# Access Compliance Report

## Public Rights-of-Way

### (Curb Ramps)

Intersection ID: 50619	Main Street: COTTON_GUM_RD	Cross Street: YELLOW_OAK_RD	Location: NE
ADA ID: CF400D4F1E1F	Ramp Type: Perp	Initial Pass/Fail: Fail	Overall Compliance: No
		Severity Score: 25

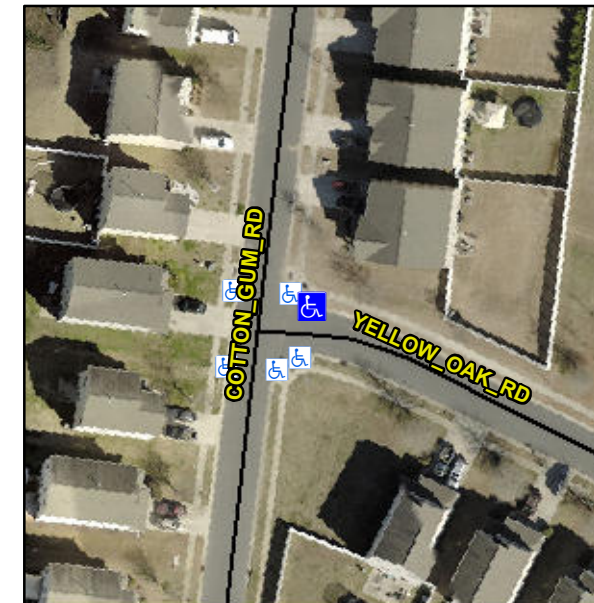
**Not Found, R304.2.2**

Compliance	Description	Data	Compliance	Description	Data
N/A	Ramp Length (in)	49.0	No	Ramp Slope (%)	18.1
Yes	Ramp Width (in)	48.0	Yes	Ramp XSlope (%)	2.0
N/A	Flare Type LT	N/A	N/A	Flare Type RT	N/A
N/A	Flare Slope LT (%)	N/A	N/A	Flare Slope RT (%)	N/A
N/A	Flare Traversable LT?	N/A	N/A	Flare Traversable RT?	N/A
N/A	Landing Length (in)	N/A	N/A	DWS Provided?	N/A
N/A	Landing Width (in)	N/A	N/A	DWS Contrast?	N/A
N/A	Landing Slope (%)	N/A	N/A	DWS Length (in)	N/A
N/A	Landing X Slope (%)	N/A	N/A	DWS Full Width?	N/A
N/A	Landing Curb? (Y/N)	N/A	N/A	DWS Offset (in)	N/A
N/A	Shared Landing?	N/A			
N/A	Gutter Ponding?	N/A	N/A	Gutter Slope (%)	N/A
N/A	Gutter Lip Ht (in)	N/A	N/A	Gutter X Slope (%)	N/A
N/A	Painted X Walk1?	No	N/A	Painted X Walk2?	N/A
	X Walk 1 Direction	To S		X Walk 2 Direction	N/A
N/A	X Walk 1 Width (in)	N/A	N/A	X Walk 2 Width (in)	N/A
	X Walk 1 Slope (%)	2.1		X Walk 2 Slope (%)	N/A
	X Walk 1 X Slope (%)	1.7		X Walk 2 X Slope (%)	N/A

**Remove & Replace Entire Ramp.**
